CHARTER TOWNSHIP OF CHOCOLAY

PLANNING COMMISSION AGENDA

**Agenda Item: IX.A Final Site Plan Review Application SR 24-03 – Dollar General Store
30520**

Issue Brief: Site Plan Review Application SR 24-03 – Dollar General Store # 30520

SHEET
C1

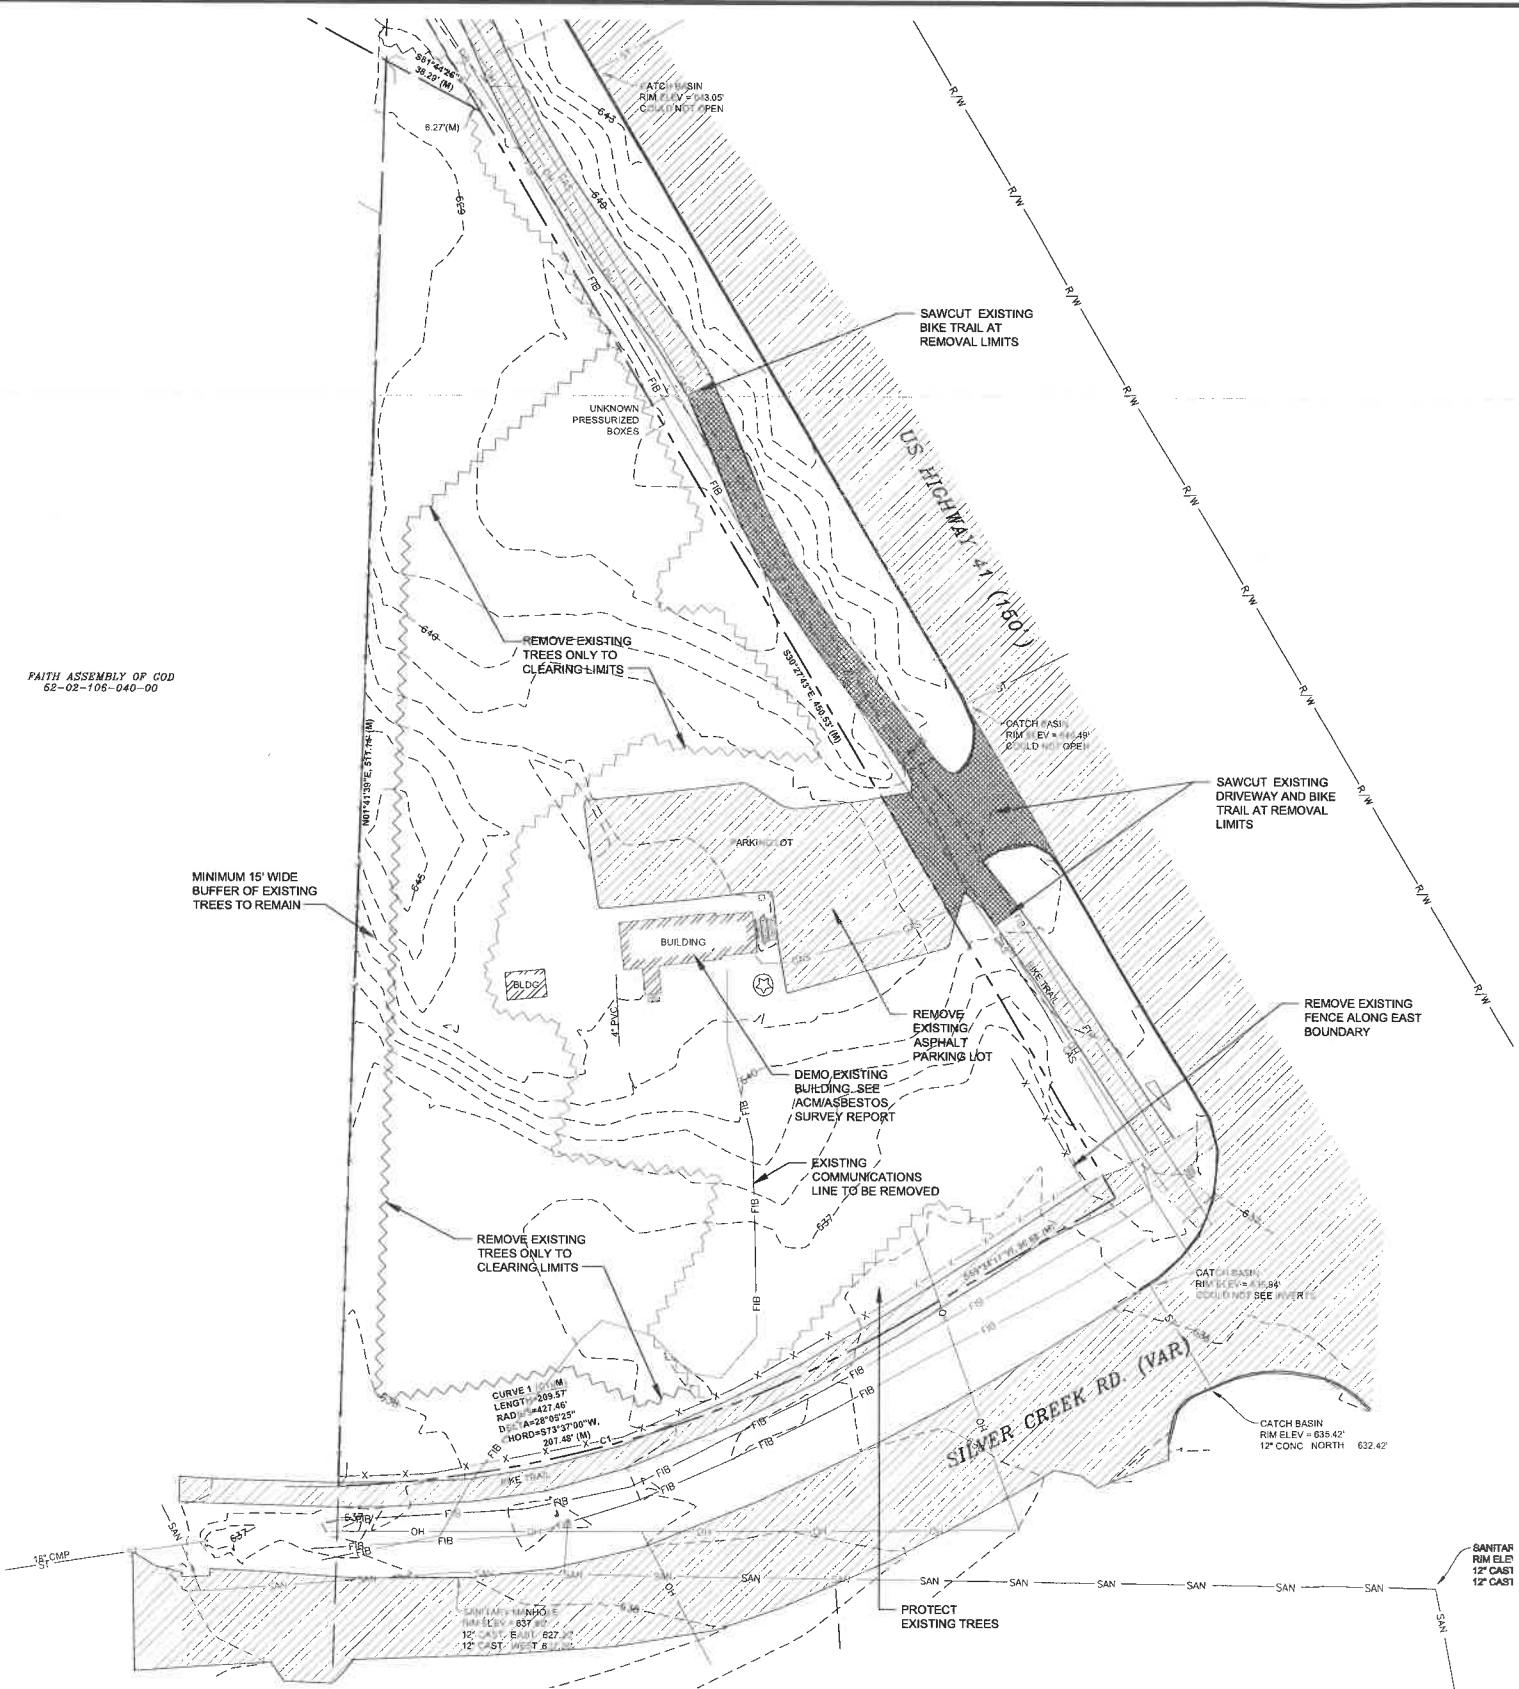
Based on this requirement, the site plan does not conform to this requirement. The site plan shows the building as 12,480 square feet, which indicates that 62 parking spaces are required; the site plan shows 49 parking spaces.
